# SUBMISSION

NorthConnex SSI 13\_6136

Community Against  
Polluting Stacks

**Figure 1: Portal placement.** NorthConnex proposed portal ★ CAPS proposed portal ★

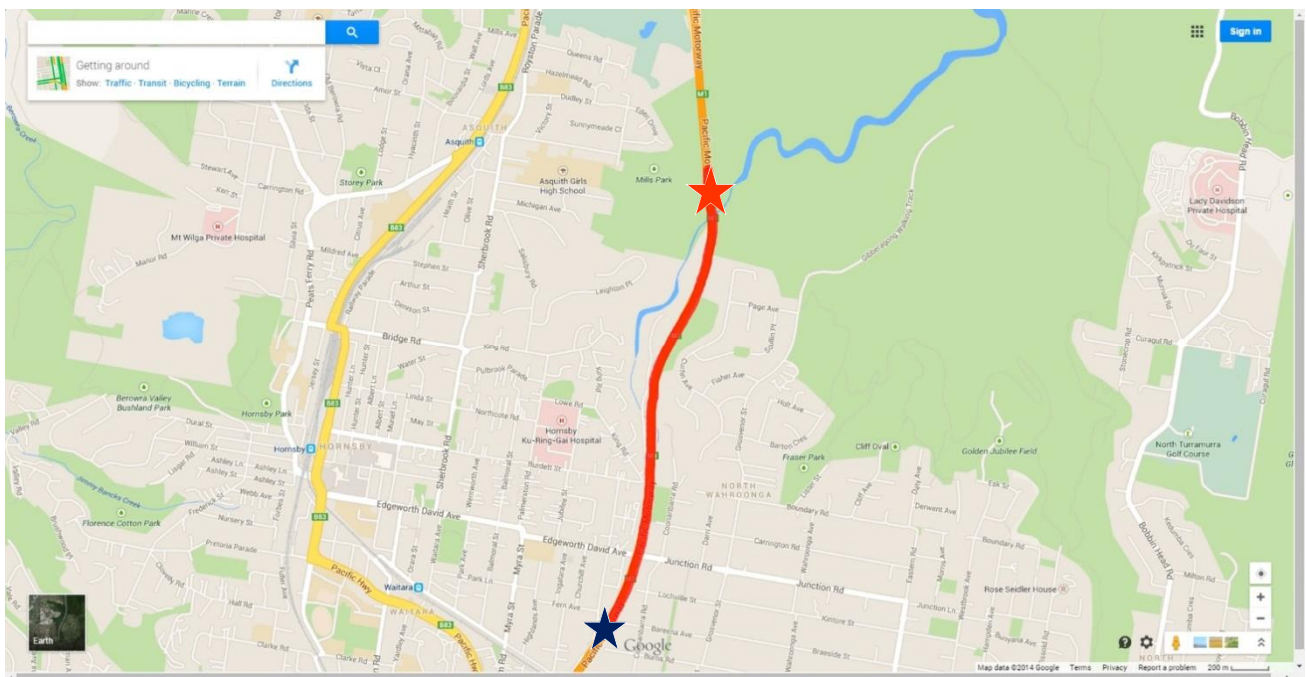
Also in placing exit portals away from residential areas there will be other massive benefits for the community including:

- Significant reduction in construction impacts including reduced noise, vibration, dust, amenity, traffic and visual impacts.
- Reduction in private property acquisitions.
- No loss in private property values.
- Reduction in visual impacts from surface infrastructure.

**Figure 2:** Portal located near Pearce's Corner

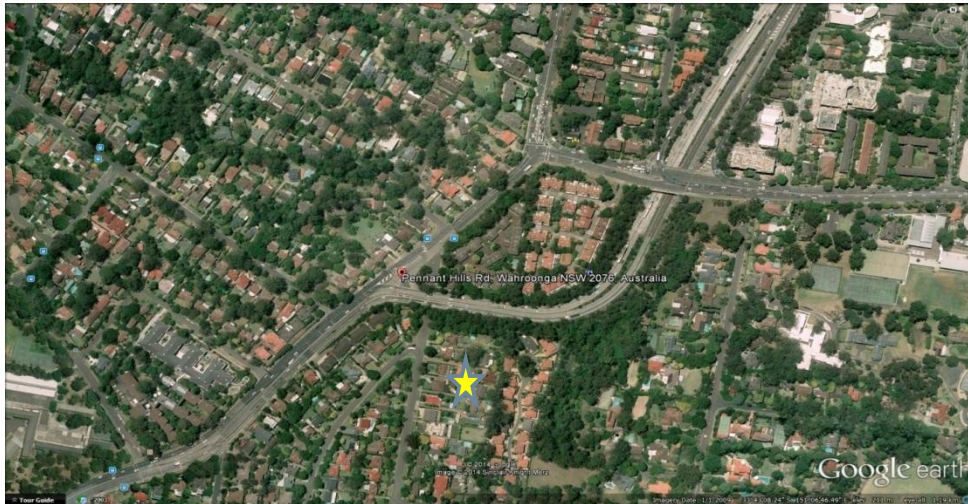
For the Pacific Highway/Pennant Hills exit portal located near Pearce's Corner - there are no feasible options to move the portal to an area of lower population density. At this portal, there will be an 800-850m long off ramp with no associated stack, and where jet fans will be expected to overcome the piston effect, despite there being no jet fans for the final 300m of tunnel. The alternative options for this location include:

- Revised ventilation design to ensure that there are no portal emissions – and a commitment from NorthConnex that there will be no future emissions from this portal.
- Installation and operation of inline tunnel filtration system. This system would not be large as the Pacific Highway/Pennant Hills off ramp is relatively short and only one lane wide – and could easily be installed on RMS land at the Pearce's Corner construction compound.
- RMS could offer to purchase properties within a 200m radius (at unaffected market value, plus costs eg stamp duty, removalist fees, etc).

Figure 3: Position of CAPS proposed portal ★, with exhaust stack ■ vented into Ku-Ring-Gai National Park

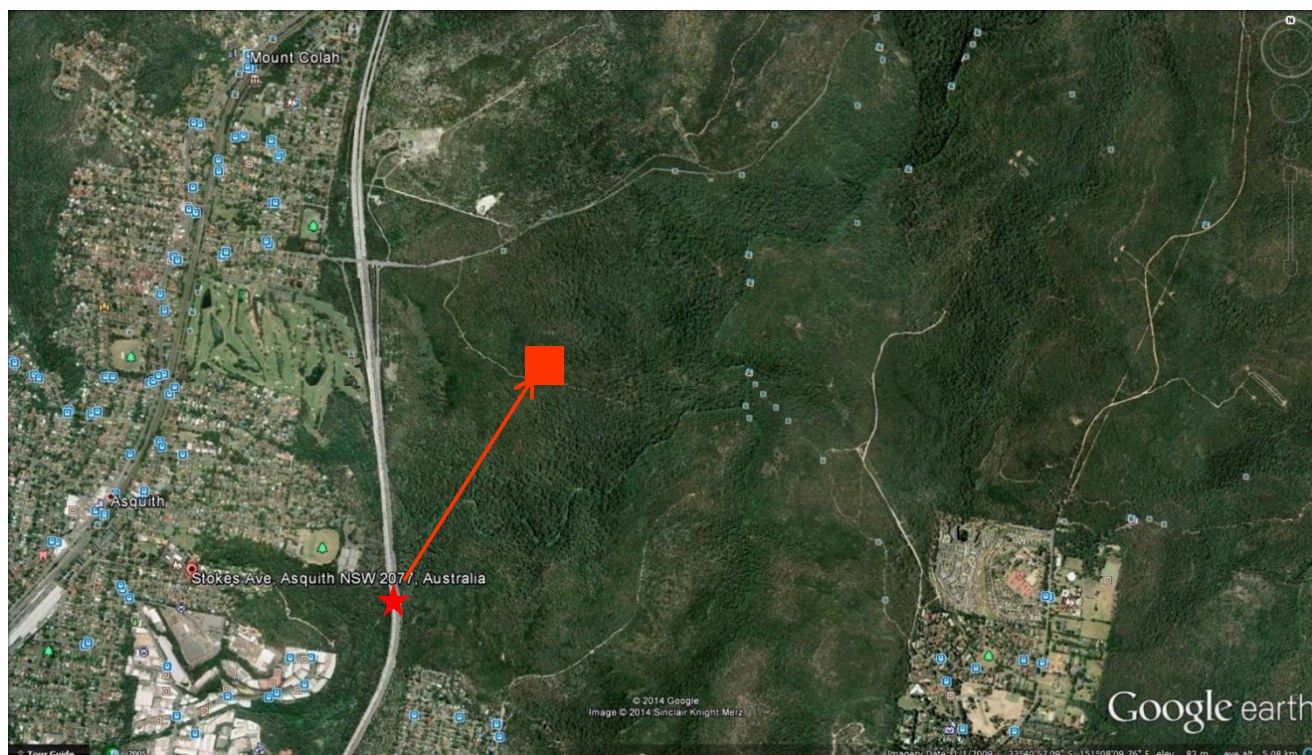
Whilst separating the portal and stack consumes more energy, it does not alter the effectiveness of the tunnel ventilation system. As the stack would be away from residential, this may also allow construction of stack and associated services to continue out of hours.

Moving the northern tunnel portals and stack away from residential areas is in keeping with the comment made by Steve Cornish (Program Manager, Transurban) that this would be "better for the community" (April 2014).

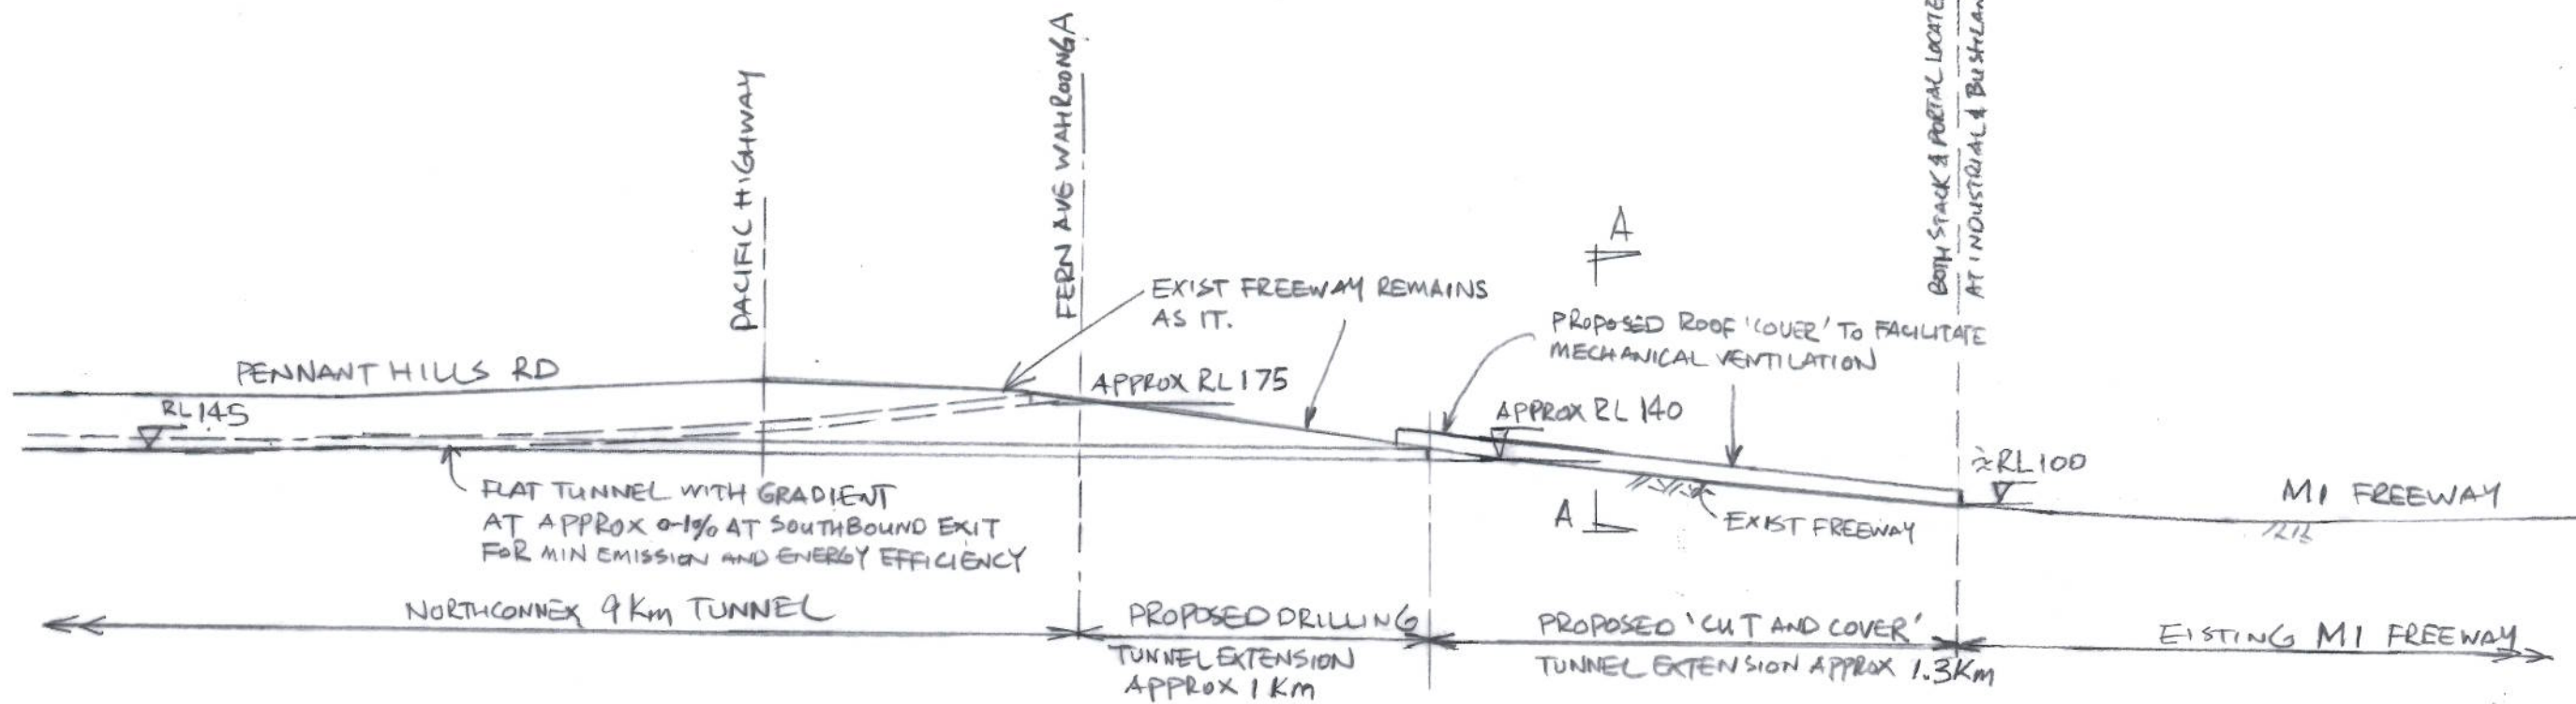
The geological long section of the tunnel presented in Appendix D of the EIS shows that the tunnel from the M2 portals (at about 123 metres RL) dips significantly below the proposed NWRL (to an RL of about 75m) before rising to about RL 175 at the M1 portals in Wahroonga. Because of this significant sag in the tunnel, both southbound and northbound vehicles experience high road grades – which result in the generation of significantly higher quantities of pollutants.

A much better solution would be to reduce the grade to as close to zero as possible. While this is not possible with the M1 portals being located in Wahroonga, however, if the portals were located on the M1 in line with Stokes Avenue in Asquith (which is about RL 121 metres), a zero grade tunnel at approximately 120 metres RL becomes a closer reality. The only issue is the interface with the NWRL and a low point just north of the M2. A more complex tunnel alignment and construction methodology would be required in this area (with NorthConnex going over the NWRL slot rather than under), however, there is no technical reason why this could be achieved. As the NWRL would not be an operational rail line (and NWRL tunneling may not have even reached this location by the time NorthConnex starts tunnel construction), the construction and safety risks are significantly reduced.

ALTERNATIVE 'CAPS' PROPOSAL FOR 'CUT & COVER'  
TUNNEL EXTENSION AT WAHRONGA  
AT 21/8/14

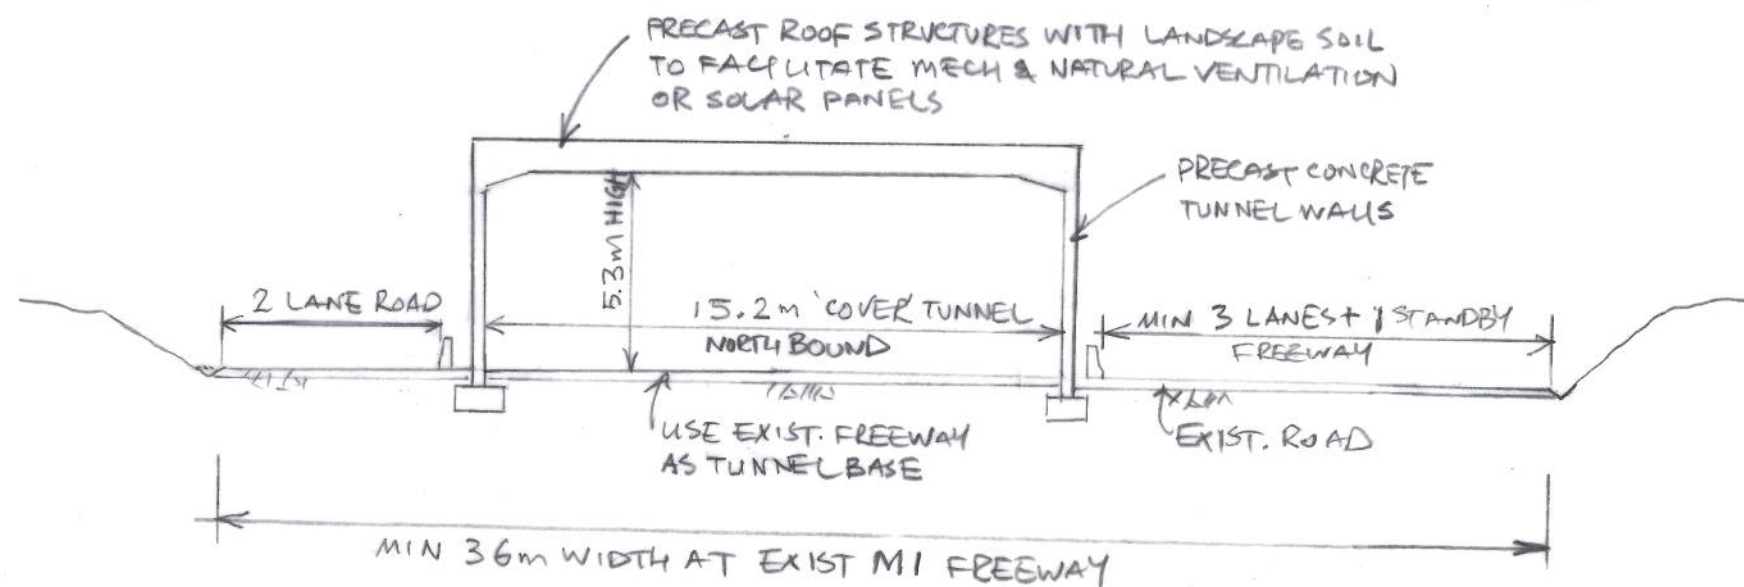
Another alternative to extend the tunnel further north would be to cover the existing M1 with a concrete structure. Basically once the tunnel reaches RL 140 metres instead of continuing to tunnel up to RL170 metres at Woonona Ave, a flat tunnel would be constructed which would exit about 1 kilometre north of the currently proposed M1 exit portal location. For another kilometre the tunnel could be extended using an above ground concrete tunnel. The cost of this type of construction would be significant lower than underground tunneling (about 75% lower) – and appropriate safety and egress requirements could be easily implemented. A diagram showing the concept is presented on the following page.
